RE: Williamsburg Landing Nursing and Living Facility
(Now Woodhaven at Williamsburg)
Plan No. SP-50-96
BMP ID Codes: CC 011 (BMP 1 Dry Pond)
AES Project No. 8162

Stormwater Management/BMP Record Drawing and Construction Certification Review Tracking Form

Project Name: Williamsburg Landing Maintenance Building
County Plan No. (List any amendments): SP-0037-2010
Stormwater Management Facility Type: Storm Pipe Only

DRAINAGE RECORD DRAWING
WILLIAMSBURG LANDING, INC.
WOODHAVEN EXPANSION
PHASE II
Jamestown District James City County Virginia

DRAWING NO. C010

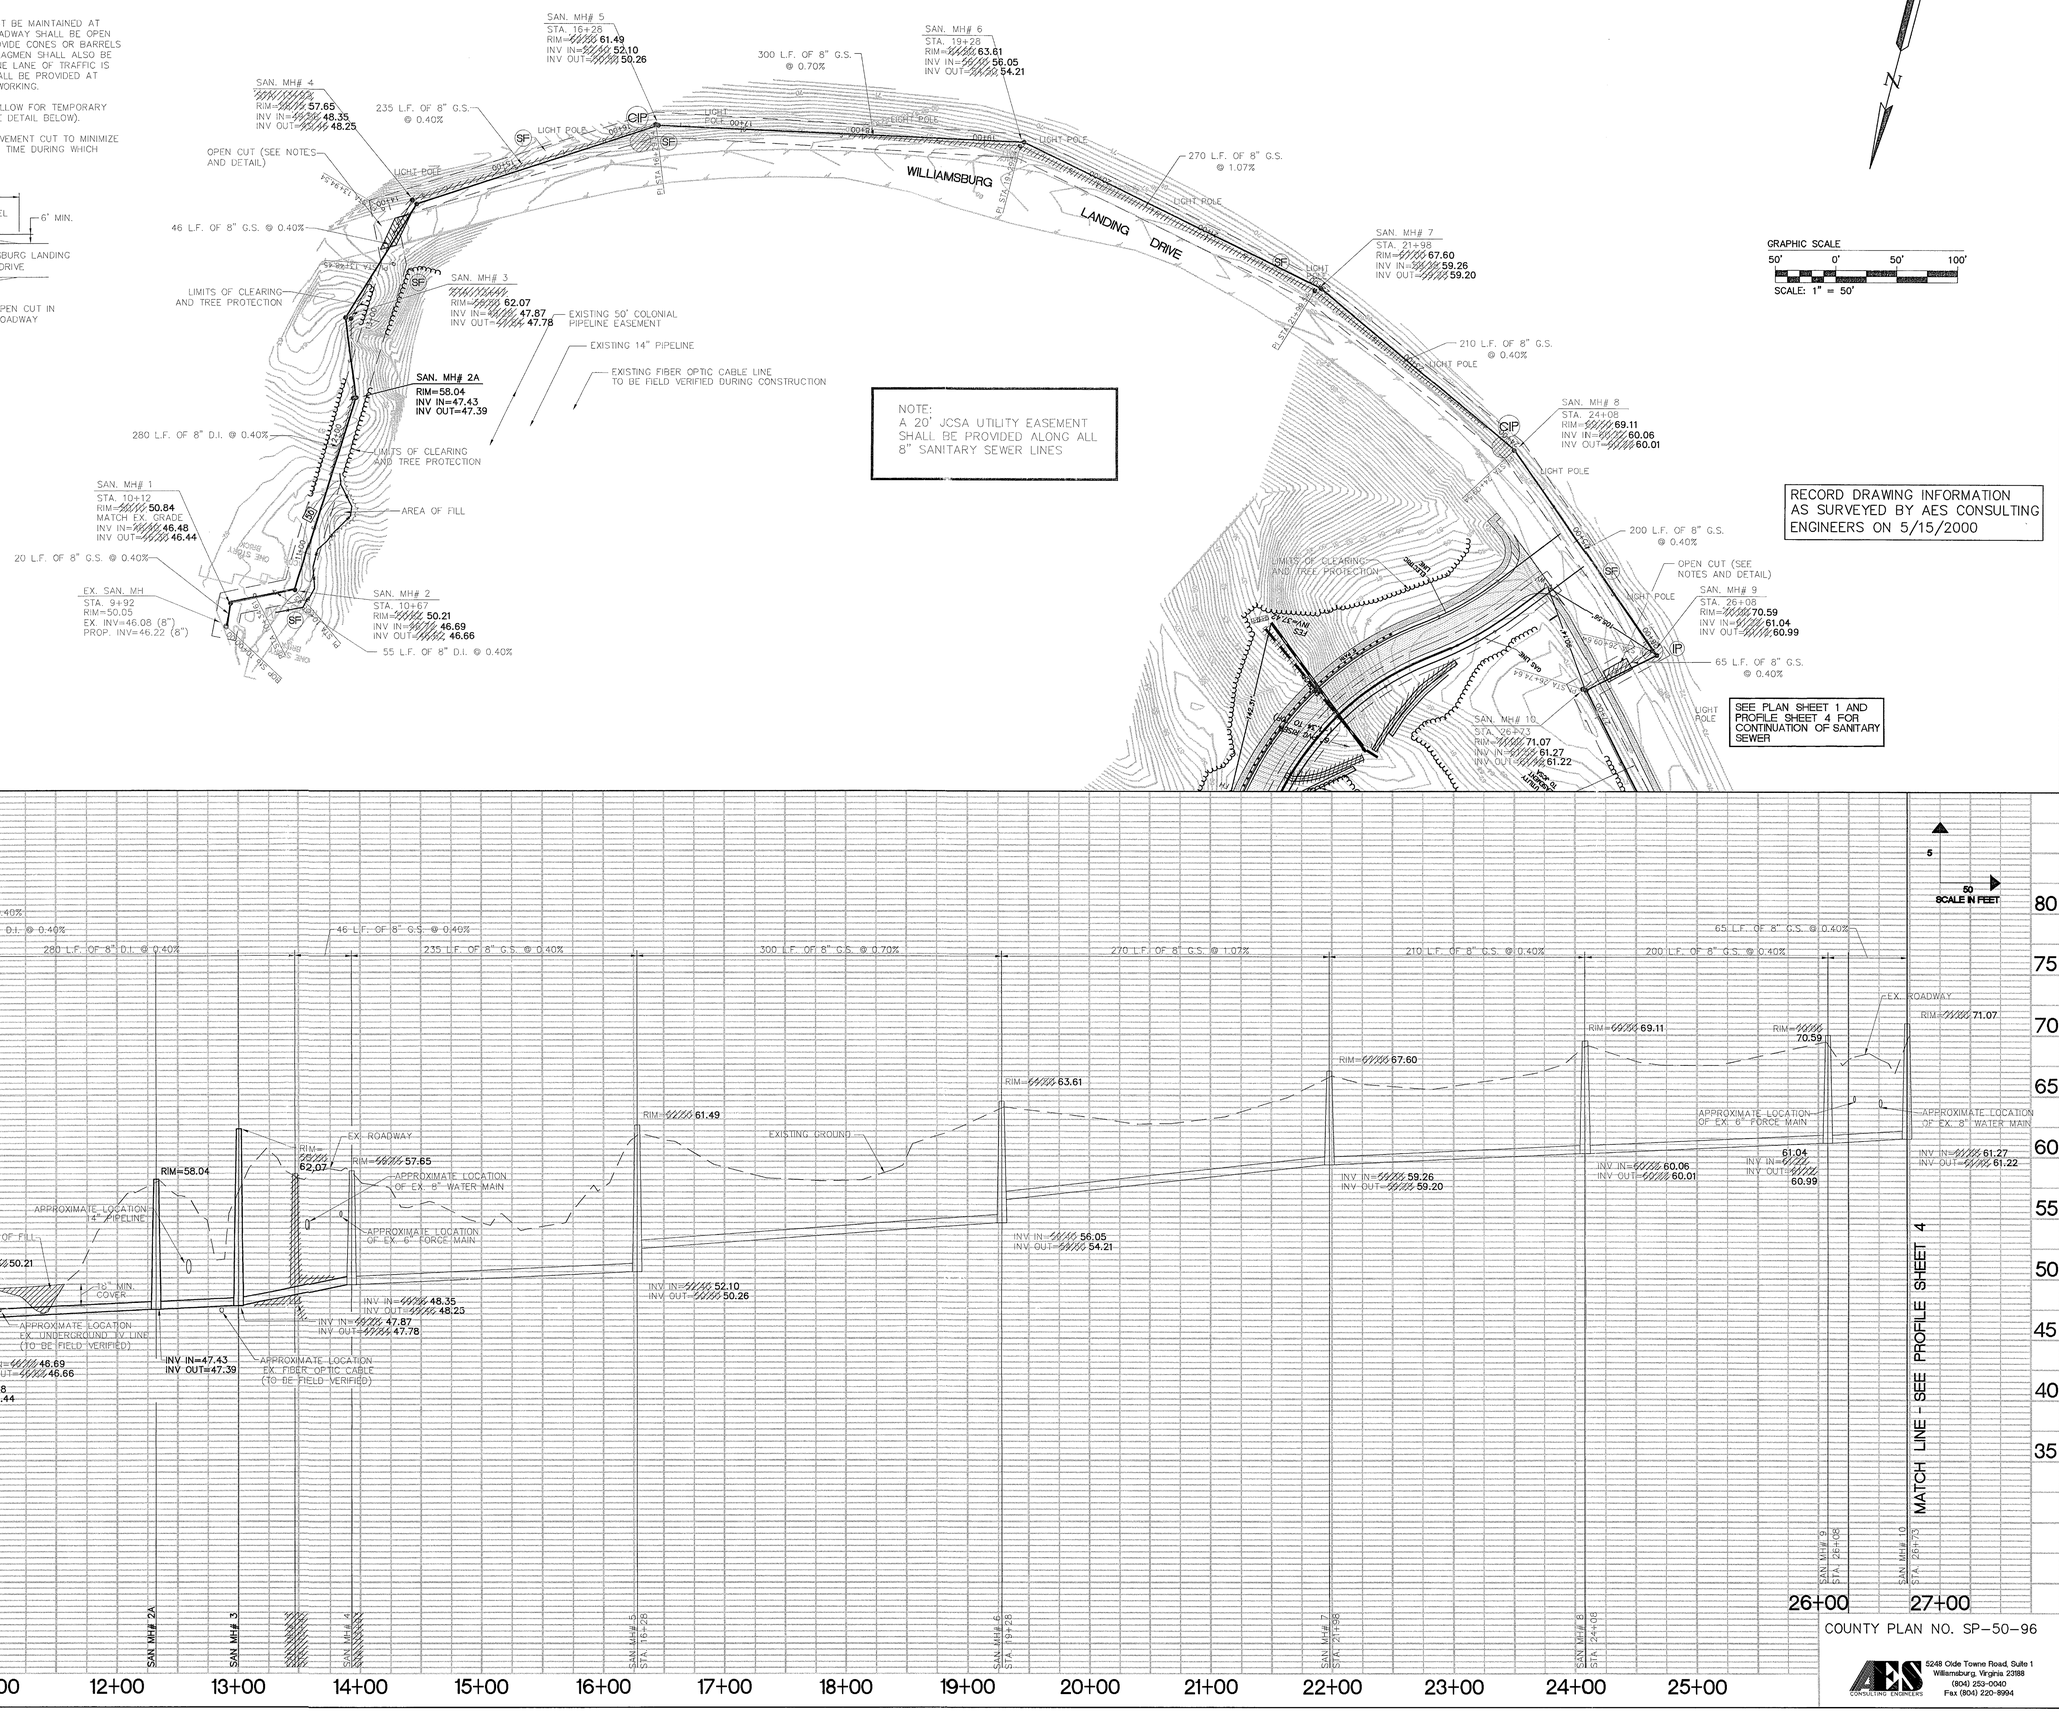
4. Dry Pond # 1. The as-built invert-in and invert-out elevation for the pond outlet barrel would result in an as-built pond barrel slope different from that of the approved design plan. Make this correction on the detail on record drawing Sheet C010 as necessary.
